2. NORTEL CARLING CAMPUS EXPANSION - PROPOSED MODIFICATIONS
TO
MOODIE DRIVE (REGIONAL ROAD 59) AND HIGHWAY 417
INTERCHANGE

Our File/N/Réf. **50 23-98-R059**
 Your File/V/Réf.

DATE 11 May 1998

SUBJECT/OBJET **NORTEL CARLING CAMPUS EXPANSION - PROPOSED
 MODIFICATIONS TO MOODIE DRIVE (REGIONAL ROAD
 59) AND HIGHWAY 417 INTERCHANGE**

**MOODIE DRIVE (REG RD 59) AND HIGHWAY 417
PROPOSED INTERCHANGE MODIFICATIONS
FOR NORTEL SITE EXPANSION**

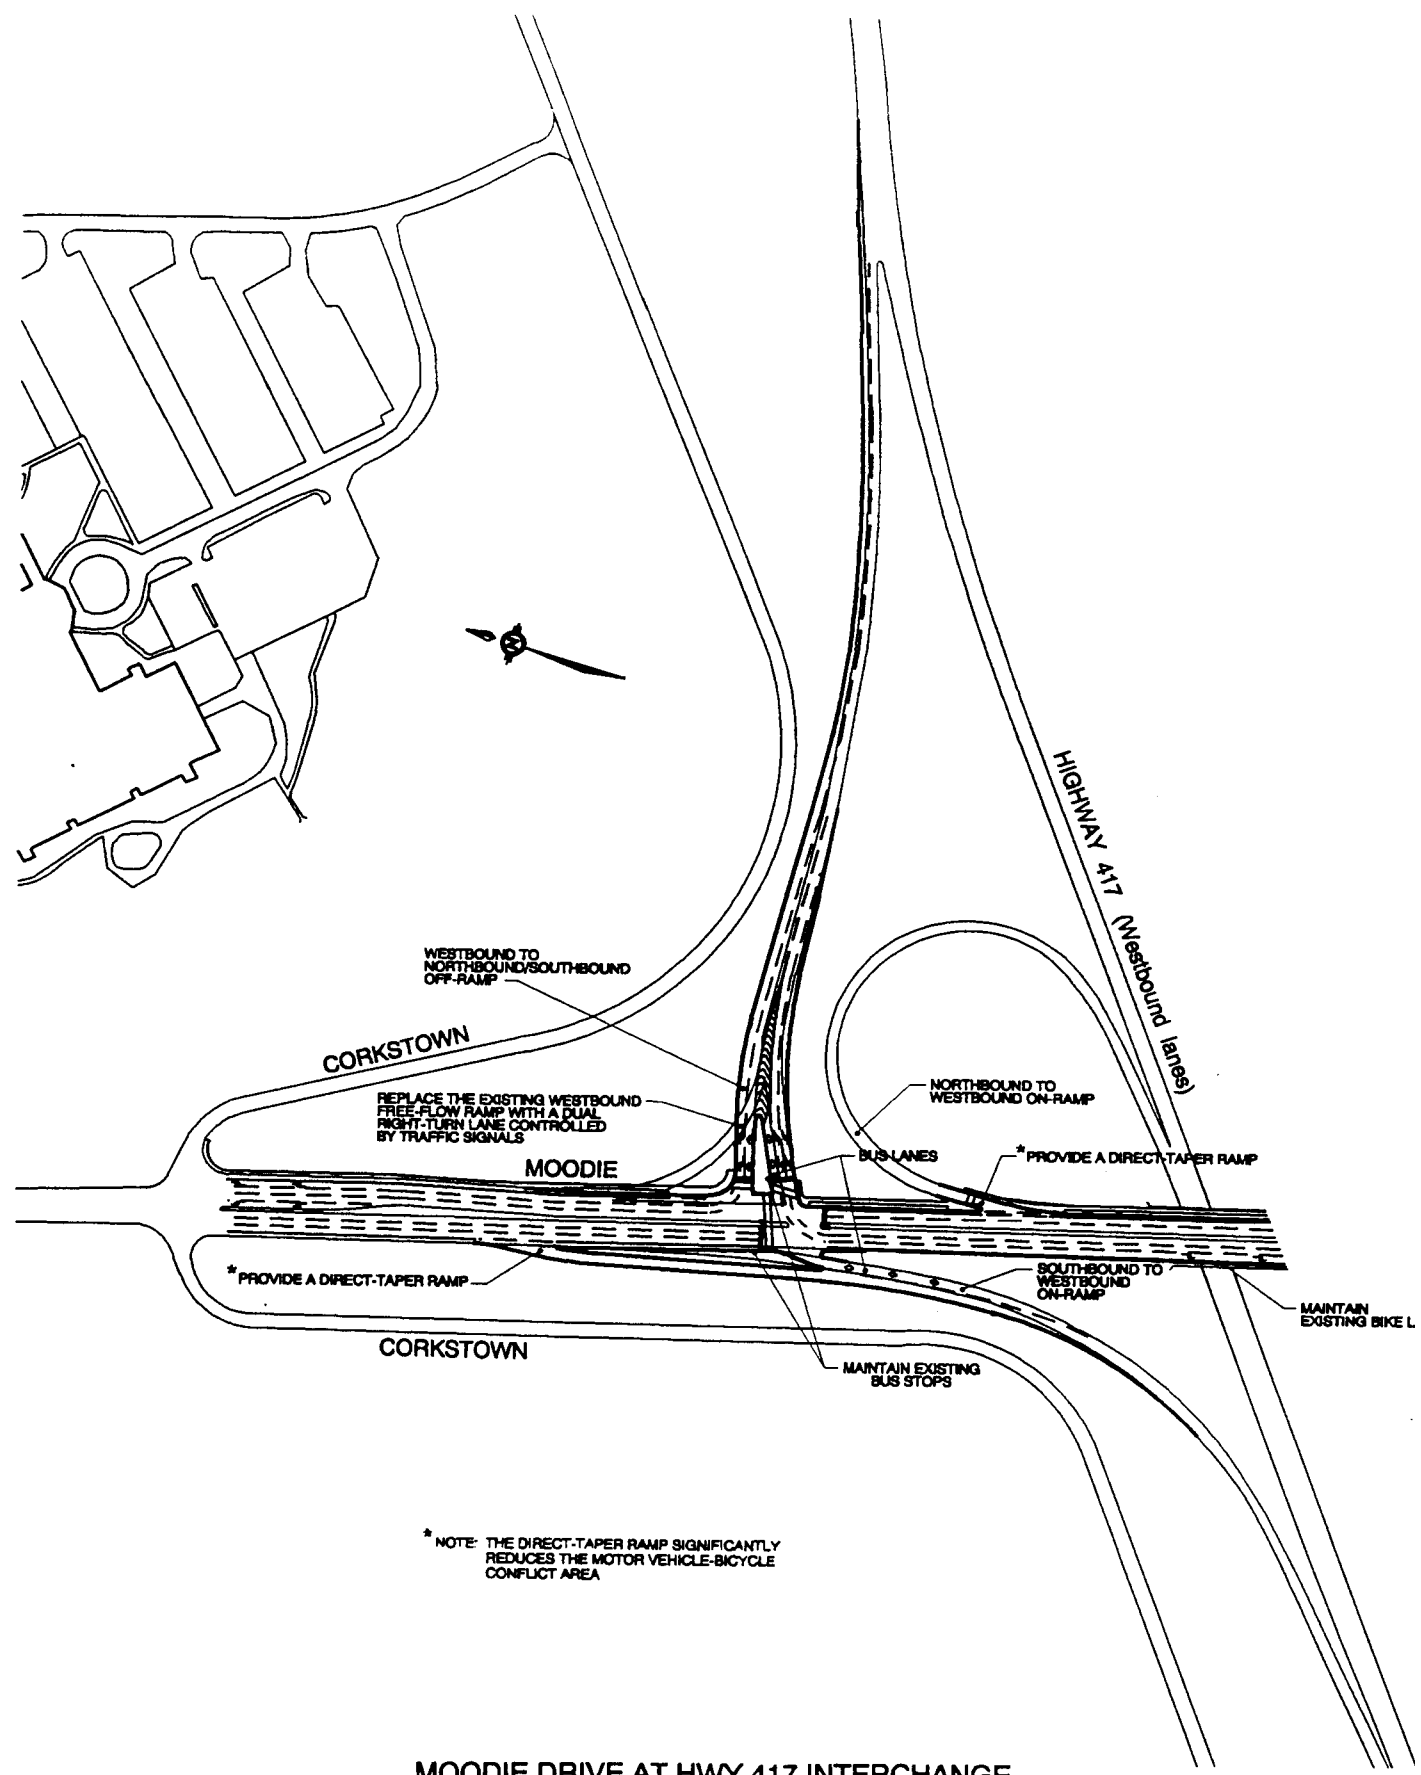
Councillor Legendre suggested an amendment to the report that a direct taper be incorporated at the intersection of Moodie and the Highway 417 eastbound on-ramp. He indicated the design had been a prime concern for cyclists who spoke to the issue last year and he wanted to ensure the safest situation possible. Doug Brousseau, Director of Mobility Services advised that the Ministry of Transportation owns the interchange and although the change would be beneficial to cyclists, it is a cost that the Region would have to bear. The Director added that the proposed design before committee is contingent upon completion of Phase II of the Nortel development.

That the intersection of Moodie Drive northbound and Highway 417 eastbound on-ramp be modified to a direct-taper design in order to provide a continuously safer corridor for cyclists.

**MOODIE DRIVE AT HWY 417 INTERCHANGE
PRELIMINARY CONCEPT PLAN
(SECTION NORTH OF HIGHWAY 417)**

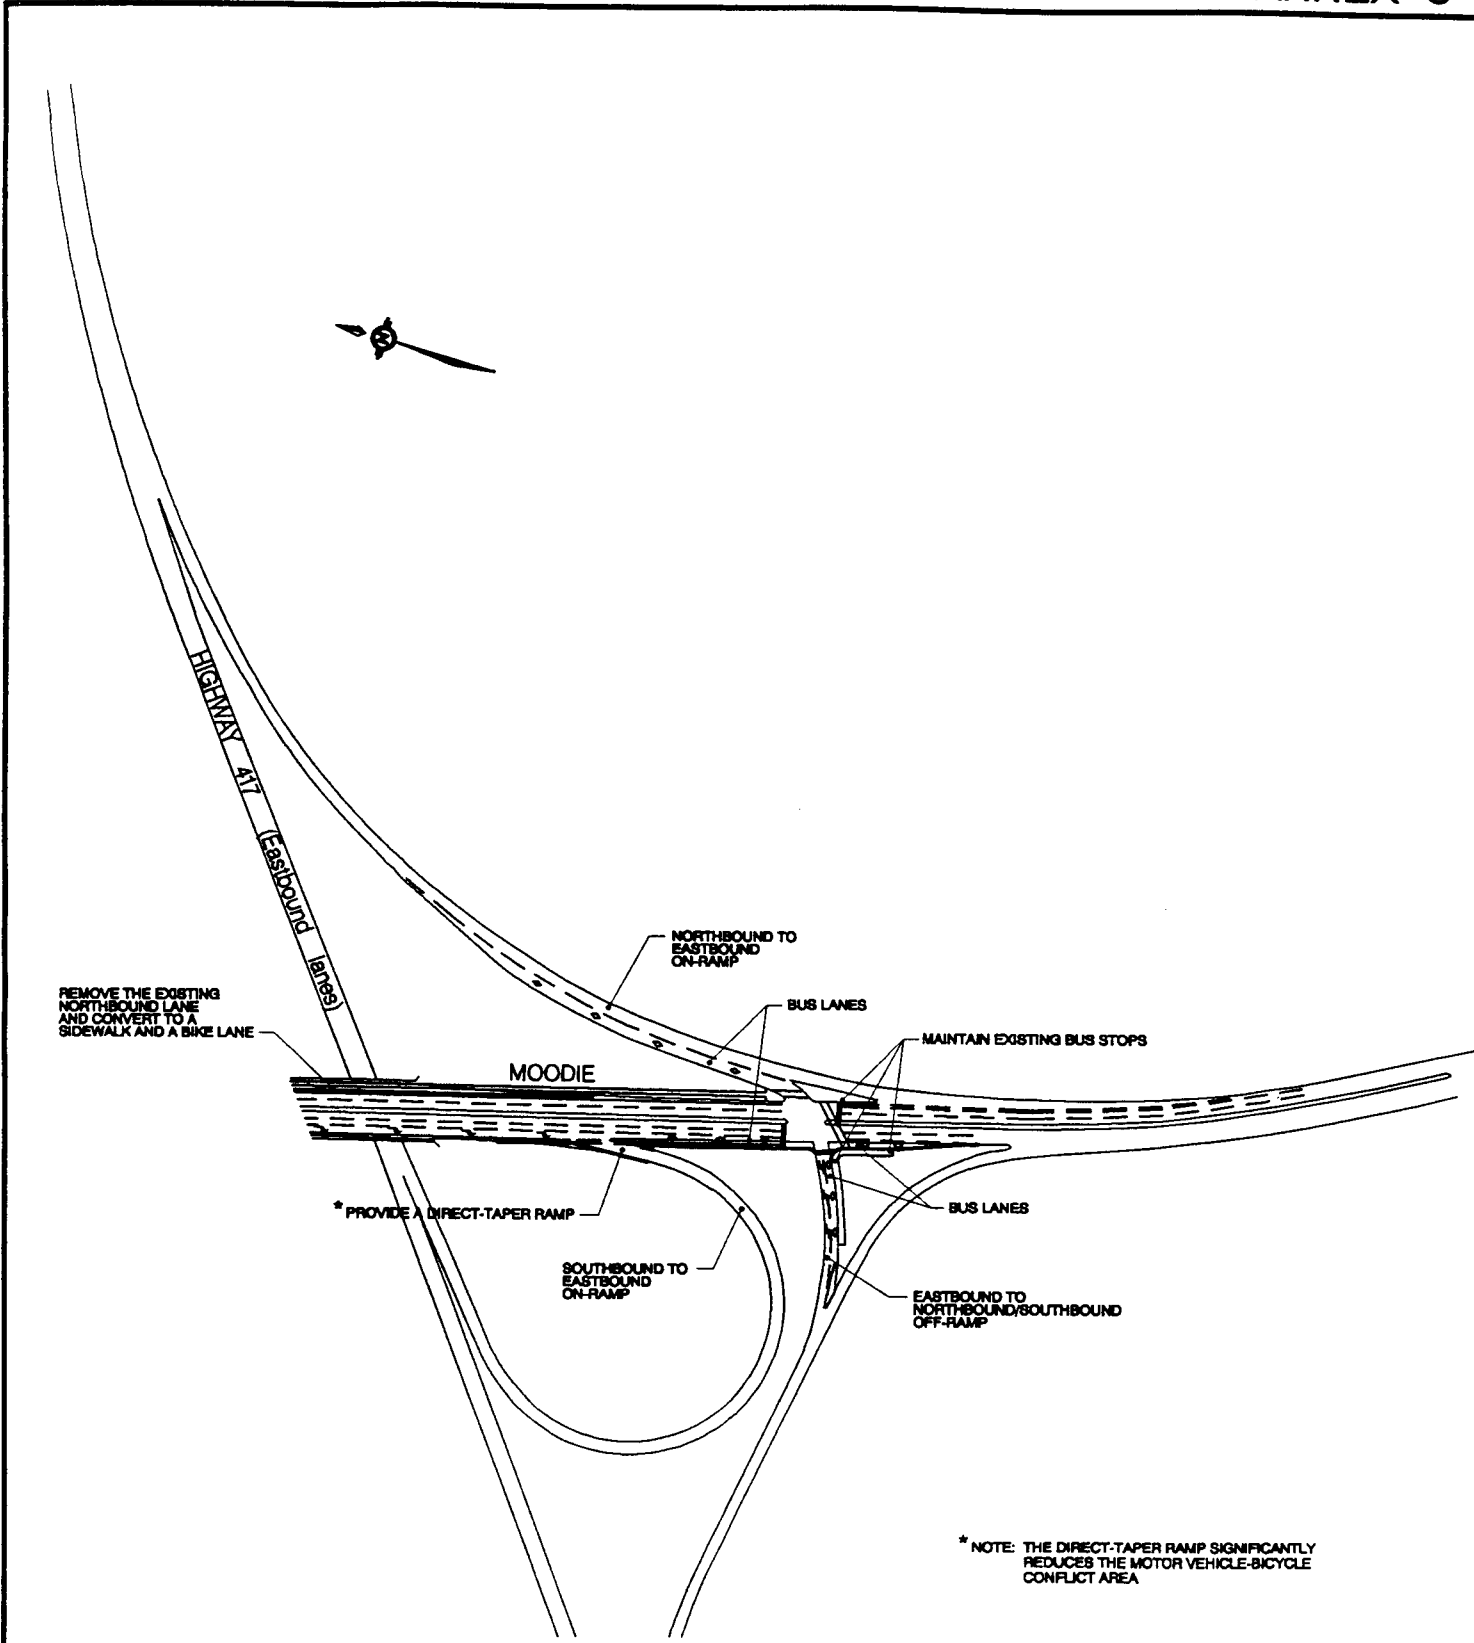
Councillor Kreling was concerned that the proposed amendment appears to imply a change in the staff recommendations and therefore an additional cost to Nortel. He viewed it as more of a stand-alone Motion that should be voted on apart from the recommendations before committee.

- 1. The endorsement of the functional design for the modifications to the interchange of Moodie Drive and Highway 417 as shown in Annex B, and;**
- 2. A communication to the Ministry of Transportation Ontario (MTO) expressing Council's desire to require Nortel to implement this design when they decide to proceed with Phase II of the Carling Campus Expansion.**
